Lithgow Environment Group Inc.

26 February 2020

Department of Planning, Industry and Environment
GPO Box 39 Sydney NSW 2001

RE: MOUNT PIPER ENERGY RECOVERY PROJECT (SSD-8294)

Figure 3-4 Indicative ERP Plant elevation against main MPPS structures (showing height above ground level)

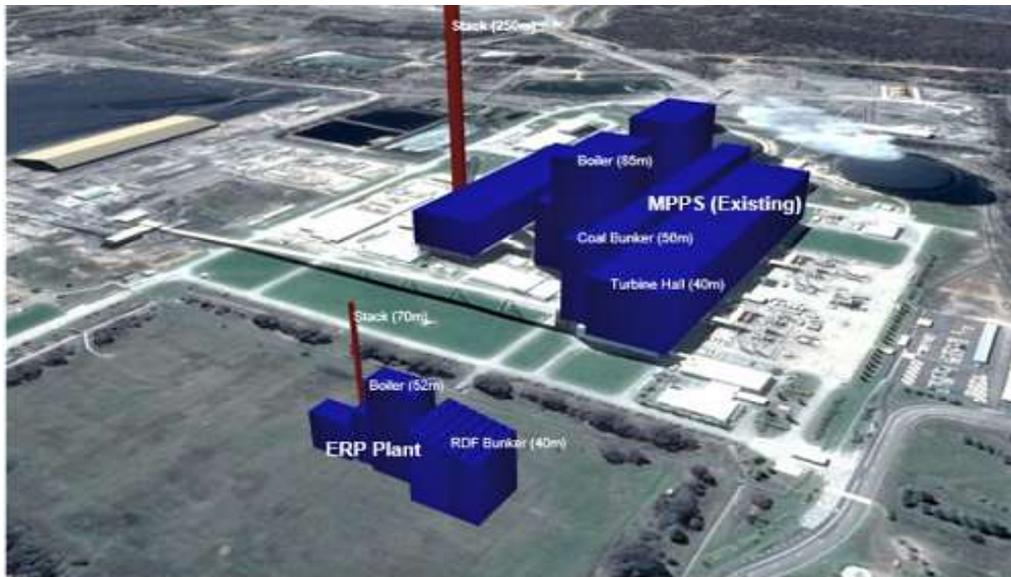
The Waste to Energy plant will only have a chimney **70 metres high**. Emissions from burning waste will be released from a 70m high stack into the air-shed at a much lower elevation than from the 250m high Mount Piper stack or the 176m Wallerawang stacks upon which the Modelling is based.

Mount Piper Power Station is located at 880 metres above sea level, and its 250m stack releases emissions at 1130 metres into the atmosphere. Wallerawang Power Station sits at 840m, and its 176m high stacks released emissions into the atmosphere at 1016 metres elevation.

The 70 metre ERP stack will release emissions into the airshed at 950m elevation, much lower than Wallerawang Power station at 1016 metres, or Mt Piper Power Station at 1130 metres.

The proposed ERP stack at 70m will be lower than the old Wallerawang Plant A stack at 80m! This has serious human health ramifications for the residents of Blackmans Flat, Pipers Flat, Portland, Cullen Bullen, Wallerawang, and Lidsdale – particularly during Temperature Inversions.

The Proponent must include Air Quality Impact Modelling based on a 70 metre high stack.
